UNITED STATES PATENT AND TRADEMARK OFFICE

APPLICATION NO.	FILING DATE	FIRST NAMED INVENTOR	ATTORNEY DOCKET NO.	CONFIRMATION NO.
10/779,661	02/18/2004	Fumitomo Matsuoka	249040US-2S DIV	1341
22850	7590	02/24/2006	EXAMINER	
OBLON, SPIVAK, MCCLELLAND, MAIER & NEUSTADT, P.C. 1940 DUKE STREET ALEXANDRIA, VA 22314			LEE, EUGENE	
			ART UNIT	PAPER NUMBER
			2815

Office Action Summary	Application No. 10/779,661	Applicant(s) MATSUOKA, FUMITOMO	
	Examiner Eugene Lee	Art Unit 2815

DETAILED ACTION

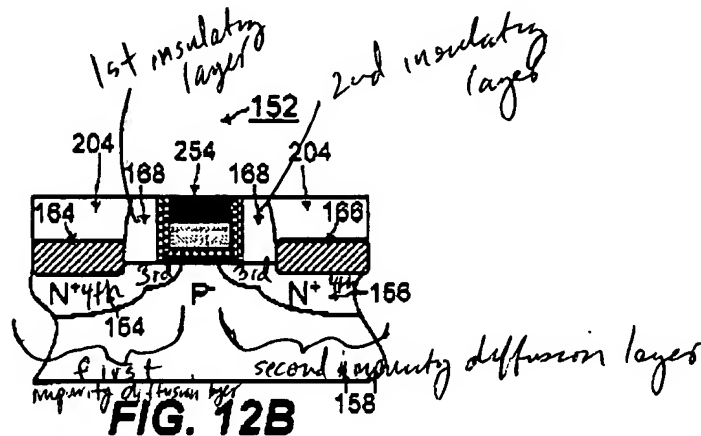
6. Insofar as definite, claims 14, 15, 17, and 18 are rejected under 35 U.S.C. 102(e) as being anticipated by Xiang et al. 6,159,782 Xiang discloses (see, for example, FIG.12B) an NMOSFET (semiconductor device) 152 comprising a P-well (semiconductor substrate) 158, drain (first impurity diffusion layer) 154, source (second impurity diffusion layer) 156, spacers (first insulating layer, second insulating layer) 168, opening (trench) 212, high dielectric constant

(gate insulating film) 223, and gate electrode material (gate electrode formed as a conductive layer) 232. In column 6, lines 50-52, Xiang discloses the high dielectric constant being Ta₂O₅.

Regarding claim 18, see, for example, FIG. 12B wherein Xiang discloses a drain salicide/source salicide (metal silicide layer) 164/166.

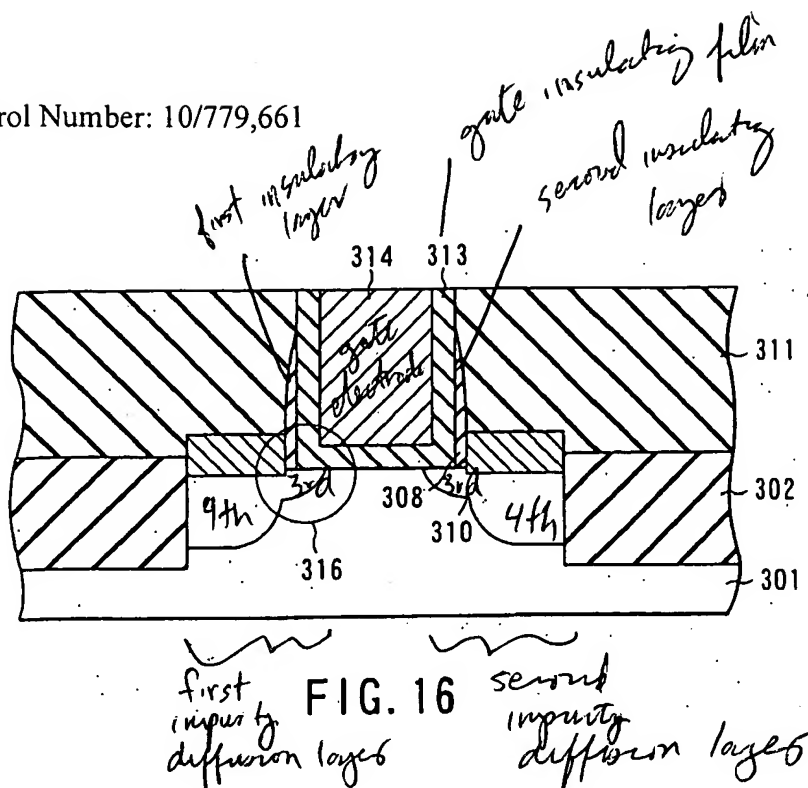
In claim 17, it is unclear what the applicant construes as the third impurity diffusion layer, and the fourth impurity diffusion layer since the fourth impurity region appears not to be beneath the second insulating layer 308 as stated in the claim. The fourth impurity diffusion layer is at a lower level than the any of the first insulating layer and second insulating layer 308,

however, it is unclear whether this “lower level” constitutes “beneath” as disclosed in the applicant’s claim since it is not directly underneath the any of the first insulating layer and second insulating layer. Appropriate clarification and/or correction is required.

Regarding claim 18, it is unclear how the metal silicide layer is beneath the first insulating layer and the second insulating layer. In FIG. 16, it appears the metal silicide layer 310 is adjacent rather than beneath the metal silicide layer even though the metal silicide layer is at a lower level than the first insulating layer and the second insulating layer. It is unclear whether the applicant interprets this lower level as “beneath” as disclosed in the claims. Appropriate clarification and/or correction are required.

In view of these 112 rejections, the figure below shows how the Examiner interprets the applicant's claims in relation to the applicant's FIG. 16. For the sake of clarity, it would like to be confirmed whether this is how the claims limitations were intended to be read, however, it is not required.
